Appendix I of RNTPC
Paper No. A/YL-KTN/878

**APPLICATION FOR PERMISSION
UNDER SECTION 16 OF
THE TOWN PLANNING ORDINANCE
(CAP.131)**

Proposed Temporary Shop and Services (Shop for Selling Vehicle Accessories, Building Materials and Convenient Store) for a Period of 5 Years

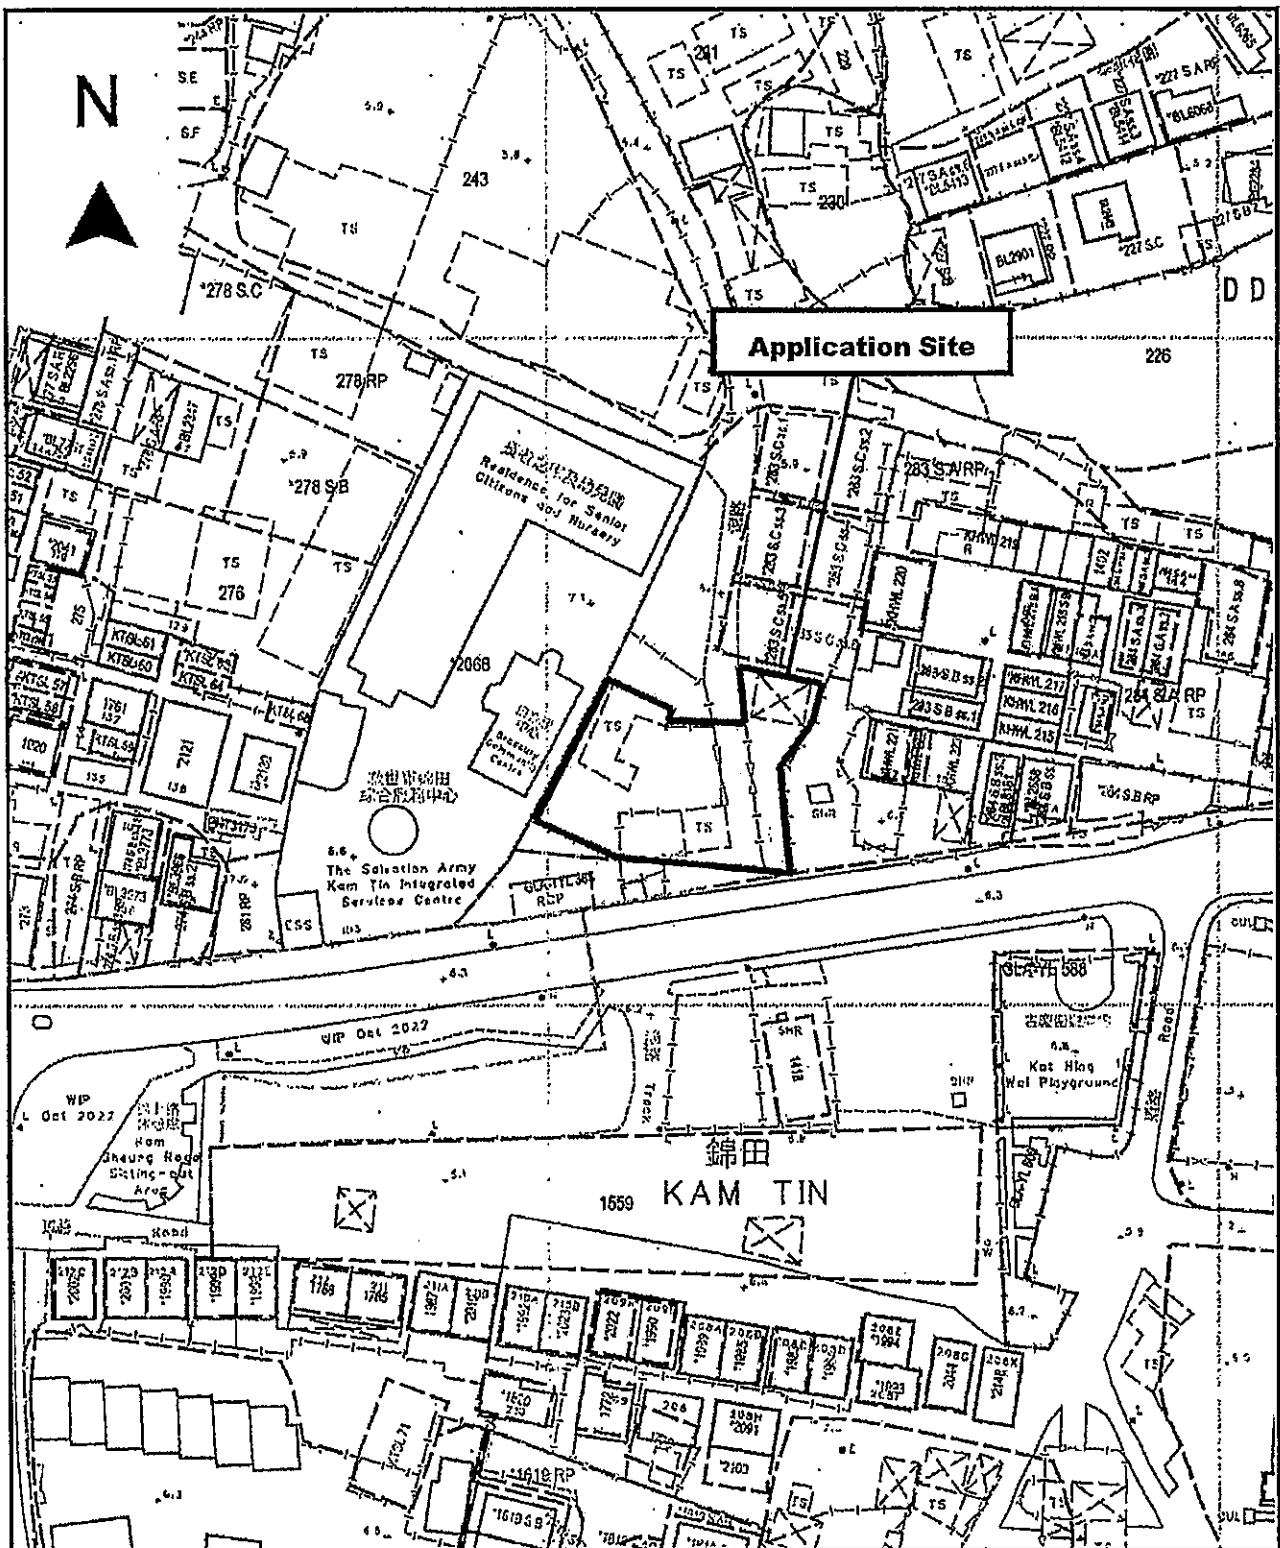
CE/MN, DSD's comments	Applicant's response
(a) Please indicate the catchment areas 1 and 2 on plan.	Revised Figure 4 is attached.
(b) The faxed copy of drainage proposal (Figure 4) is blurred, please submit a clear version for vetting. The comments provided are based on the limited information stated in the proposed drainage plan.	Revised Figure 4 is attached.

(c) The cover and invert levels of the proposed catchpits should be shown on the drainage plan for reference.	Revised Figure 4 is attached.
(d) It is not recommended to have two adjacent outlets connecting to SMH1012050 from maintenance point of view. Please review and revise accordingly.	The details has been revised and shown in the attached Figure 4.

<p>(h) The location and details of the proposed hoarding/peripheral wall should be shown on the proposed drainage plan.</p>	<p>Revised Figure 4 is attached.</p>
<p>(i) Cross sections showing the existing and proposed ground levels of the captioned site with respect to the adjacent areas should be given.</p>	<p>See the enclosed Figure 5.</p>
<p>(j) Standard details should be provided to indicate the sectional details of the proposed u-channel, sand trap and the catchpit.</p>	<p>The standard details for U-channel, sand trap and catchpit should be referred to CEDD Standard Drawing Nos. C 2405/1, C2406/1, C2410</p>
<p>(k) The development should neither obstruct overland flow nor adversely affect existing natural streams, village drains, ditches and the adjacent areas, etc.</p>	<p>Noted.</p>
<p>(l) The applicant should consult DLO/YL and seek consent from the relevant owners for any drainage works to be carried out outside his lot boundary before commencement of the drainage works.</p>	<p>Noted.</p>

1. R-to-C (b) & (c): The scanned drainage proposal is again illegible, e.g. the cover and invert levels cannot be read. Please provide a clear version. Please also provide the cover and invert levels of SMN1012050 on plan.	Updated Figure 4 is attached.

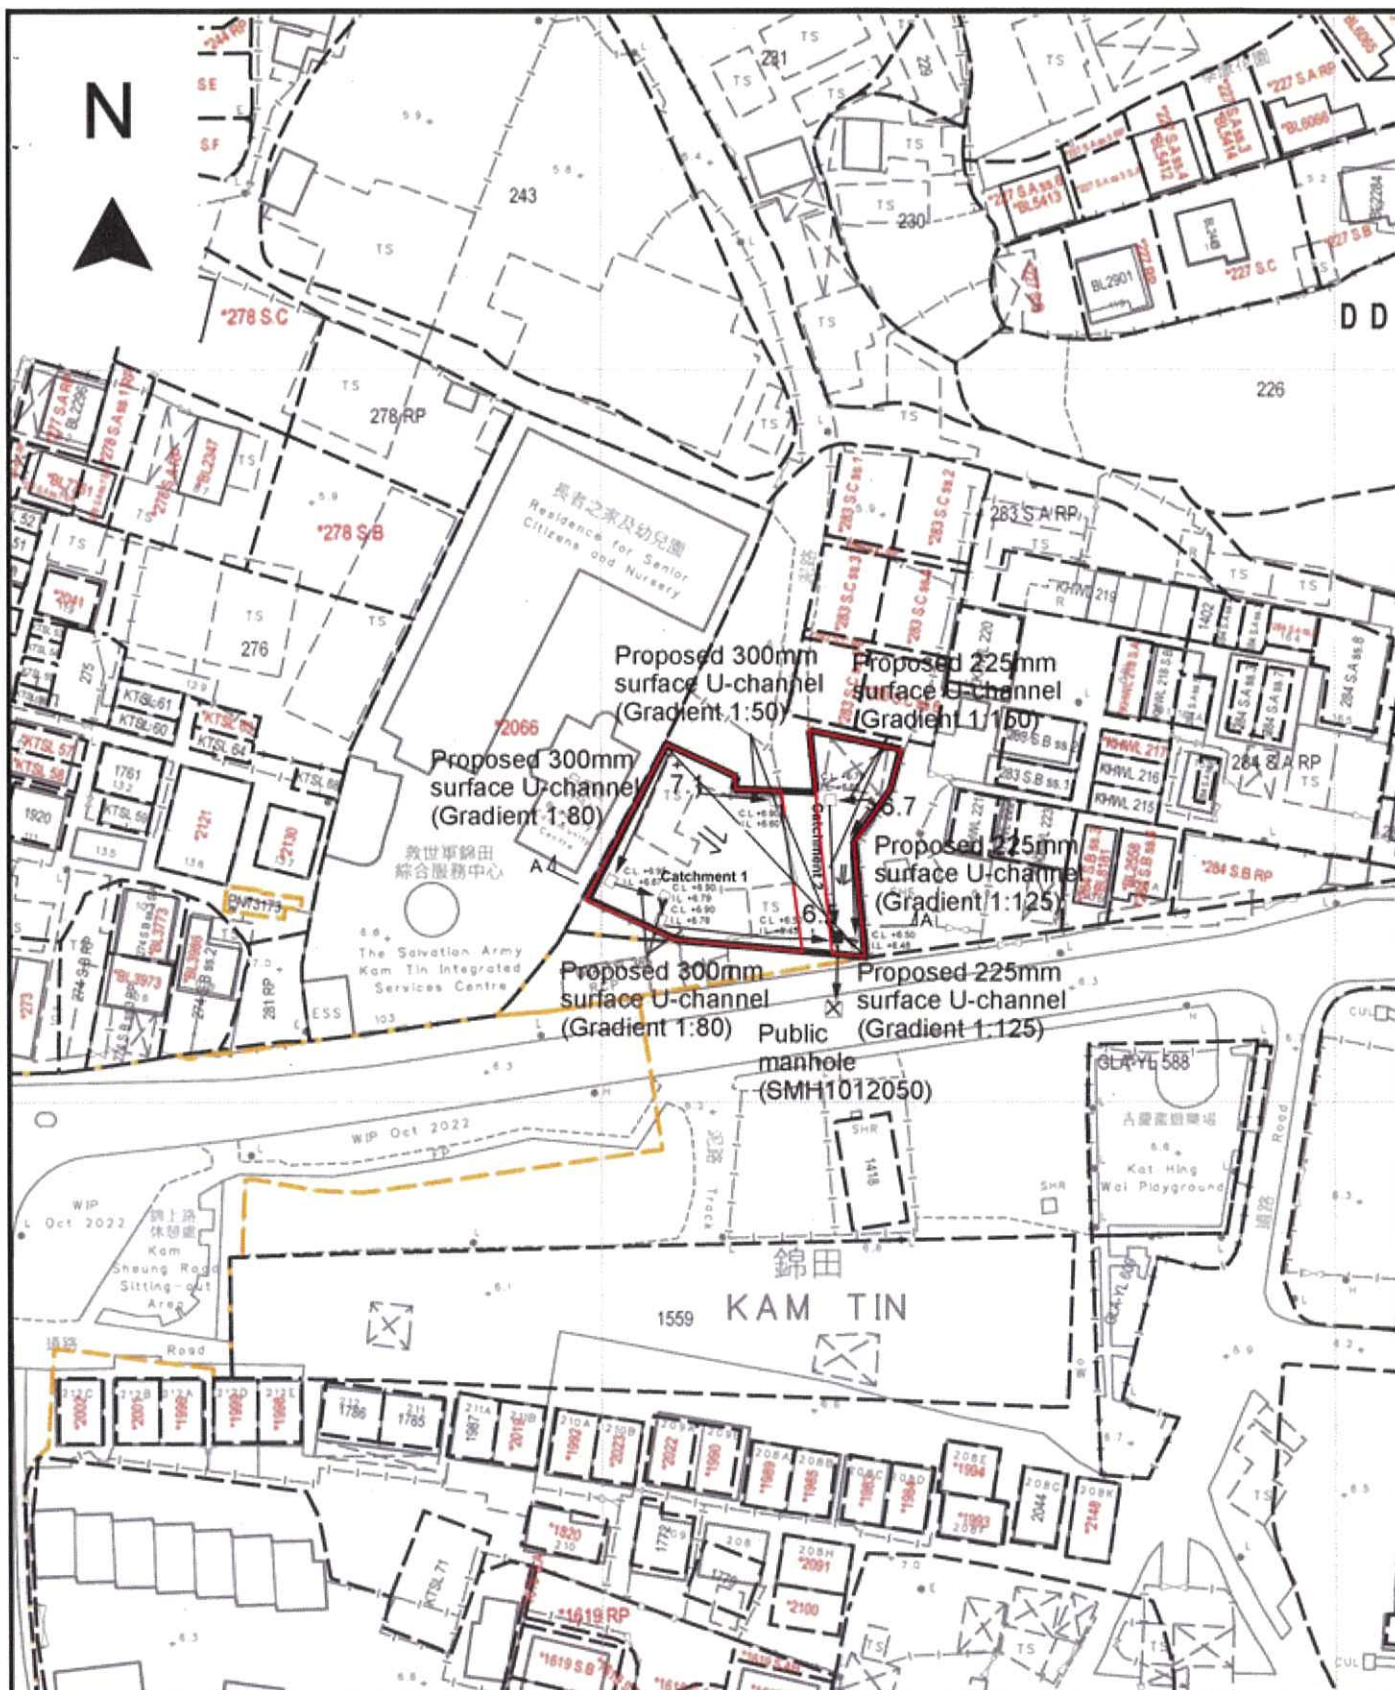
(e) The (1) connection details such as materials/ size of pipe, (2) Method Statement of Connection to SMH1012050 and (3) contingency plan of SMH1012050 collapse should be provided. The applicant must	See the enclosed Appendix A.

2. R-to-C (e): Previous comment has not been fully addressed. Please indicate in the MS that "The applicant must obtain consent from DSD prior to commencement of the drainage connection works to DSD's manhole. A pre-survey of the existing manhole condition, in a format to be agreed by DSD, shall be provided by the applicant prior to commencement of the drainage connection works". Please revise the MS.	Revised Appendix A is attached.

5. Appendix A-I & drainage plan: The size of discharging pipe/UC is not consistent. Please advise if it is a 225UC or 300mm concrete pipe. Please revise accordingly.	Revised Appendix A is attached.

- Setting out and excavate the pipeline at the location as indicated on the drainage drawing,
- Consent shall be obtained from DSD prior to commencement of the drainage connection works to DSD's manhole. A pre-survey of the existing manhole condition, in a format to be agreed by DSD, shall be provided by the applicant prior to commencement of the drainage connection works,
- Excavate and expose the connection point at the existing manhole/catchpit,
- Setting out the location of the connection point at the existing manhole/catchpit,
- Break a hole at the manhole/catchpit, the size of the hole to be large enough to install the pipe,
- Install a section of cut pipe, max. not greater than 300mm long to existing manhole/catchpit.
- Erect formwork shuttering and complete concrete surround to the cut pipe.
- Make good to the connection point.

Figure 6

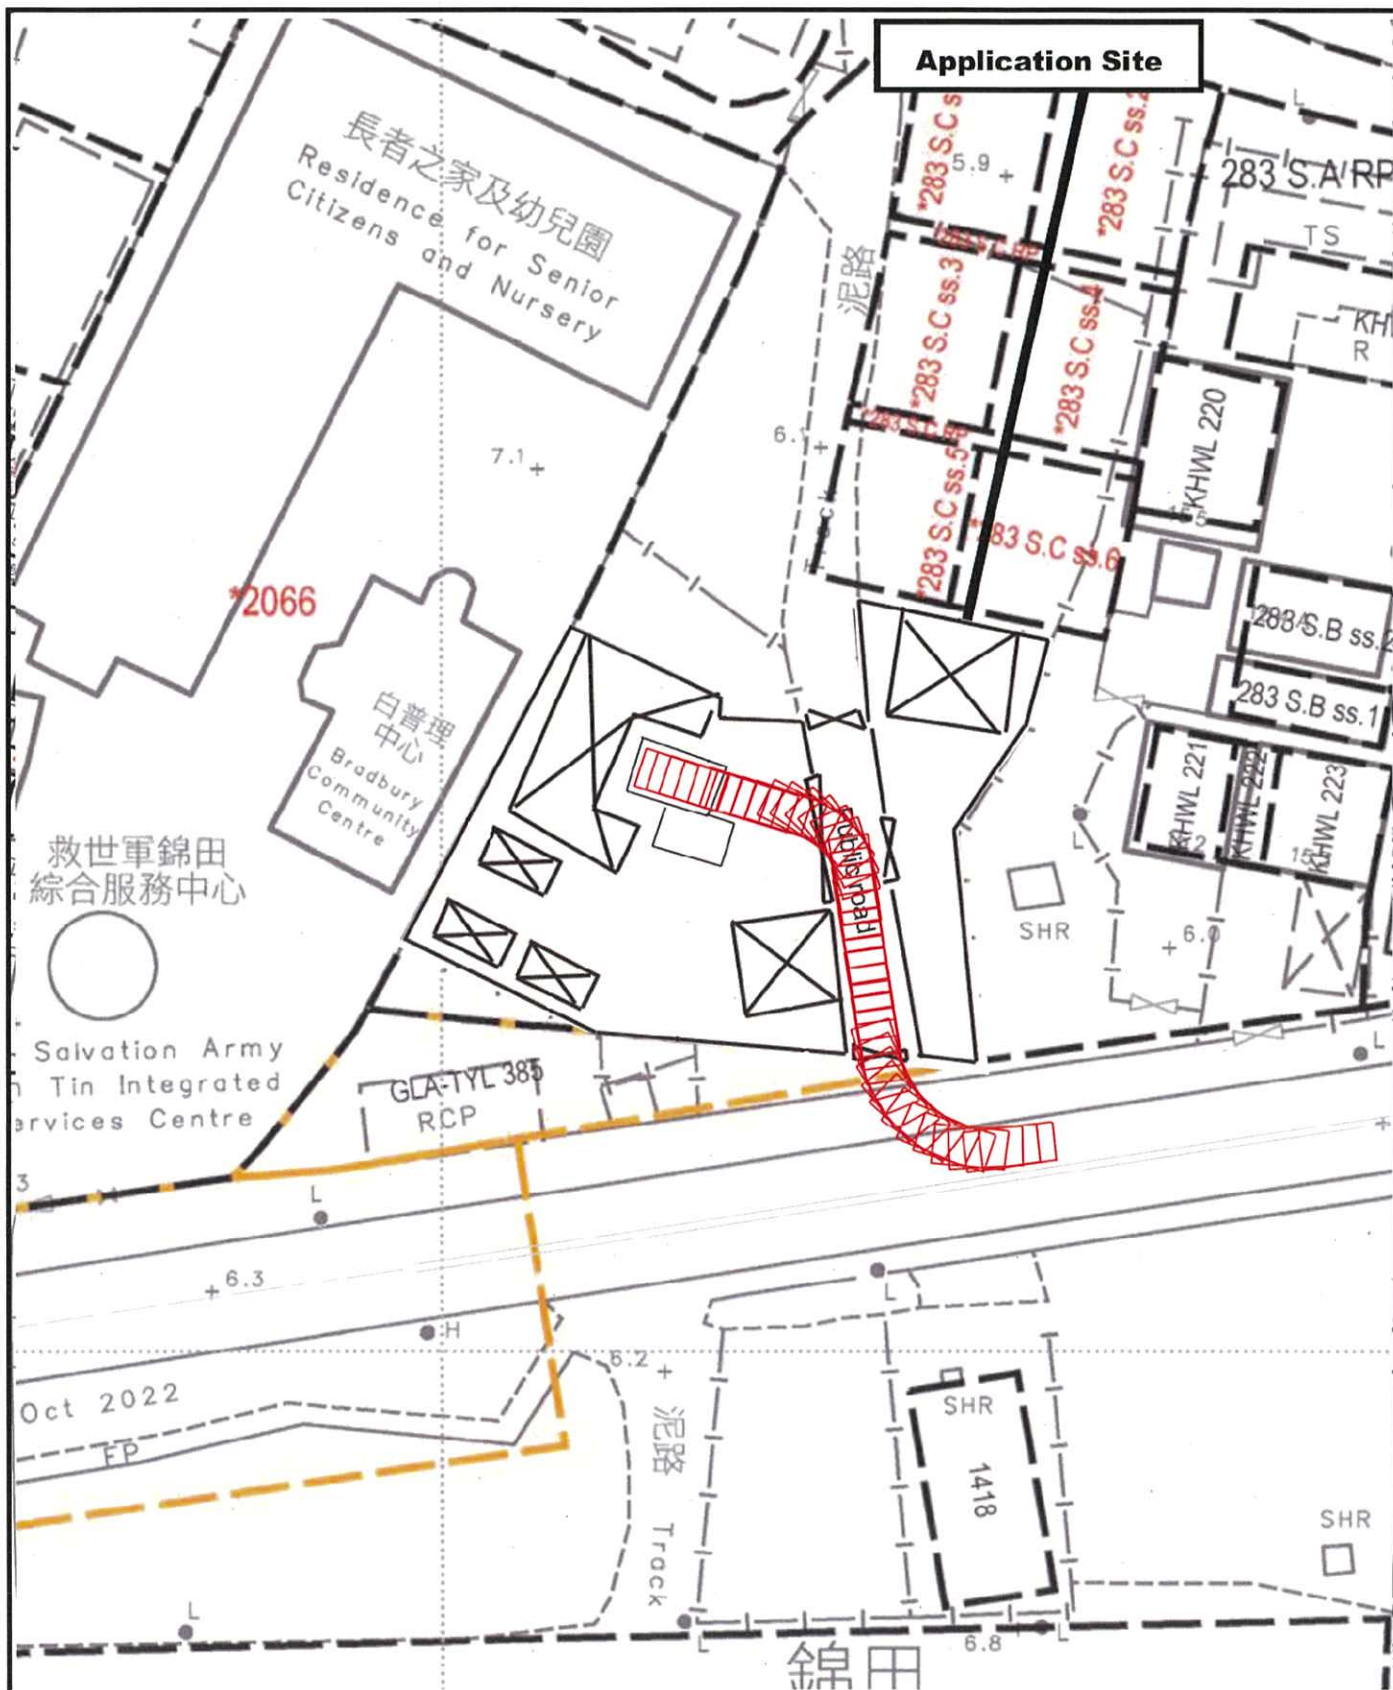
Transport Department's comments	Applicant's response
(a) The applicant should demonstrate the smooth manoeuvring of vehicles to/from Kam Tin Road, along the local access and within the site;	Noted. Please refer to Figure 6 and 7.
(b) The applicant should provide nearest public transport services and indicate on the layout plan;	Noted. Please refer to Figure 8.

FIGURE 4A

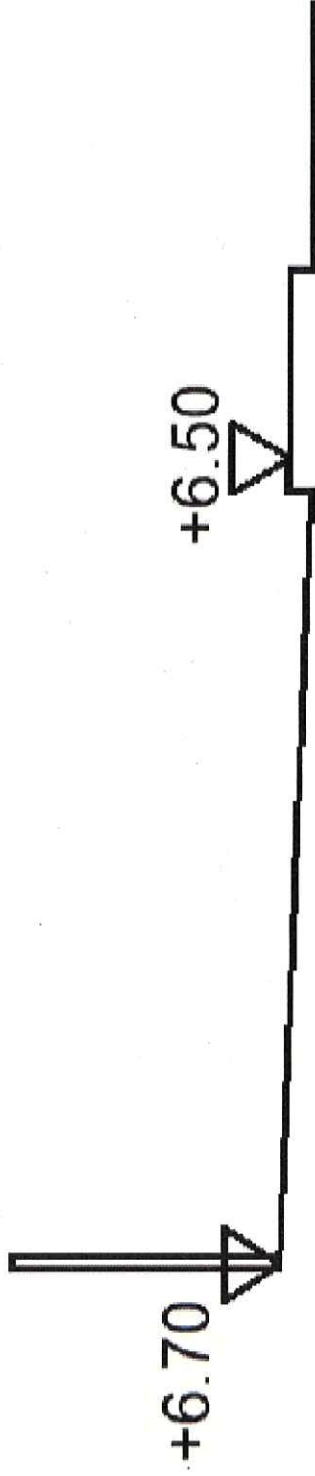
6. Appendix A-II: The connection details to SMH1012050 such as section drawings are missing. Please be reminded if the level difference between the inlet pipe and outlet pipe is greater than 600mm then please review your design which should comply with the latest SDM issued by DSD.	Figure 4A is attached.

Figure 5

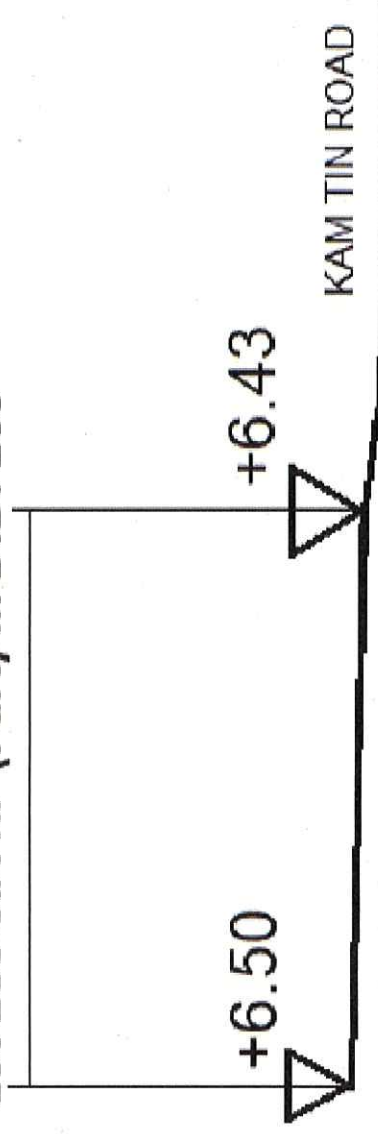
3. R-to-C (f): Previous comment has not been addressed. Please revise the MS.	Revised Appendix A is attached.
4. R-to-C (i): Please provide a cross section along north-south direction for reference. Besides, the section in Figure 5 does not correctly reflect the actual site condition. There should be an existing wall on the western side. Please provide photo/survey record to justify your section drawings.	Updated Figure 4 and Revised Figure 5 are attached.
